ITEM # <u>1</u> DATE: <u>10-17-11</u>

COUNCIL ACTION FORM

SUBJECT: POWER PLANT UNIT 8 WATERWALL INSTALLATION CHANGE ORDERS

Change Order No. 11

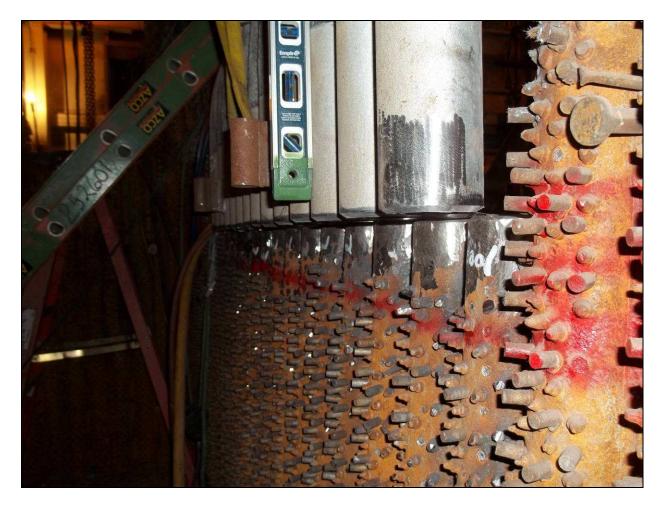
Description: When the new panels were installed, the existing front and rear wall boiler walls did not fit together with the new panels. See the photo above for an example of the misalignment. The new panels are correct dimensionally, but our existing boiler is not after 30 years of operations.

Scope: Due to the new front and rear wall panels not fitting up with the old existing boiler tubes, it is necessary to cut the existing walls down an additional 34", nearly to the header. In addition, some of the membrane on the new panels was split to allow for additional clearance to make the old and new fit together. This change order includes the labor, material and additional coating material to make the old boiler fit to the new panels.

Change Order No. 13

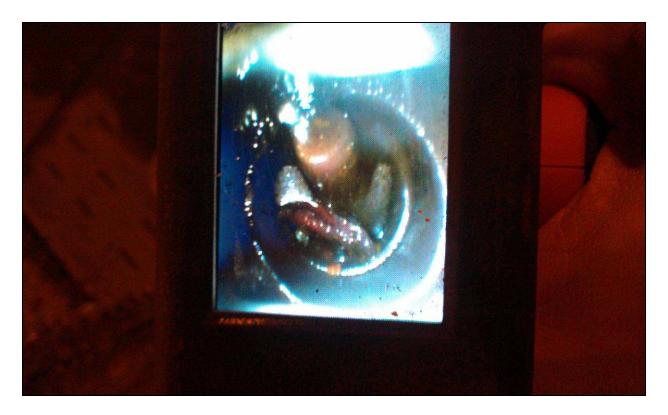
Description: During the waterwall installation, staff is taking the opportunity to inspect each of the lower waterwall headers with a remote camera. One header was found to have existing debris from previous repairs or events not related to AZCO's contract. The photo above is of the inspection camera screen showing the debris inside the waterwall header. It is not possible to clean the header from the same entry as the inspection camera so a "hand hole" plug will have to be cut-out from one of the 9 headers to allow for the cleaning.

Scope: AZCO will cut the welded plug out of the header, the City of Ames will clean the debris and AZCO will weld the new hand-hole plug.

Change Order No. 15

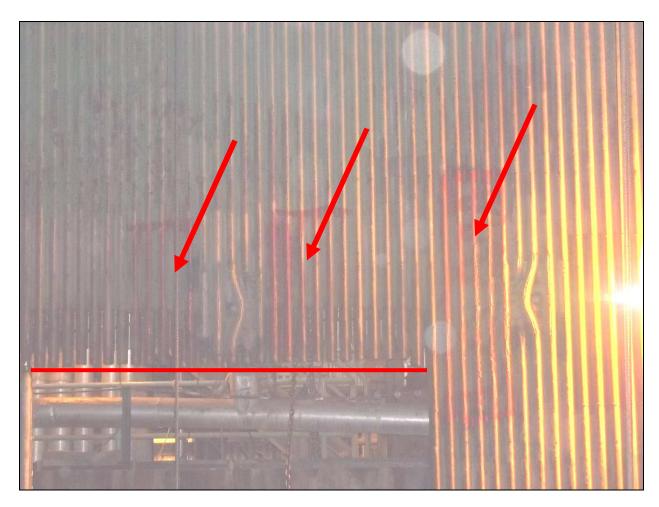
Description: Staff had the entire boiler inspected by the boiler manufacturer (Babcock & Wilcox) prior to AZCO commencing construction. The goal of the full boiler inspection was to identify areas outside the known boiler repair scope that will need repair. Additional repairs were found in the lower furnace adjacent to AZCO current workscope. Staff intends to have AZCO repair these areas in lieu of utilizing out current boiler maintenance contractor because of safety concerns and potential schedule days due to working different contracts literally on top of one another.

Scope: The picture above has an arrow pointing to one of the spray painted sections that needs pad welding. On the South and East boiler AZCO will replace twelve (12) tubes and complete 1,310 square inches of pad welding.
